- (1) This report discusses and makes recommendations on submissions received in relation to Proposed Plan Change 39 - Transport ("the Proposed Plan Change").

- (2) The purpose of the Proposed Plan Change is to review the transport provisions of the City of Lower Hutt District Plan ("the District Plan").
- (3) The Proposed Plan Change contains a complete review of Chapter 14A Transport, but also reviews other related transport provisions throughout the District Plan.

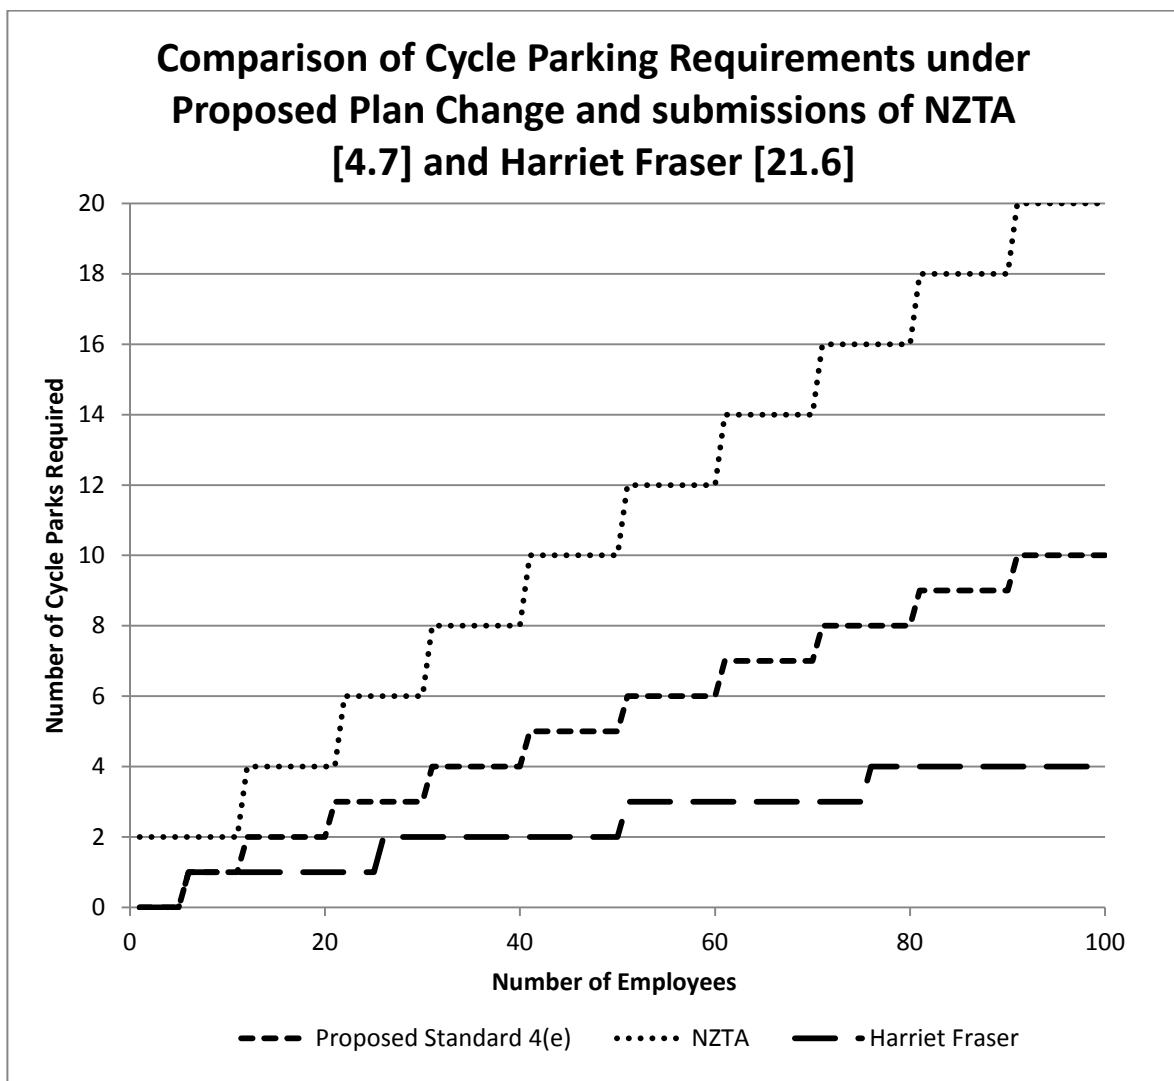
- (464) **NZTA [4.7]** submits that council should consider increasing the number of cycle parks to 2 per 10 staff members.
- (465) **Harriet Fraser [21.6]** submits that providing cycle parking facilities for around 4% of staff should be more reasonable and still allow for some variation and growth, and that Table 4-2 of Standard 4(e) be amended as follows:

<b>Number of Staff Members</b>	<b>Number of Cycle Parks</b>	<b>Number of Showers</b>
1 – 5	0	0
6 – <del>4025</del>	1	1
<del>4025</del> or more	1 per <del>4025</del> staff members <u>or part thereof</u>	1 per 100 staff members
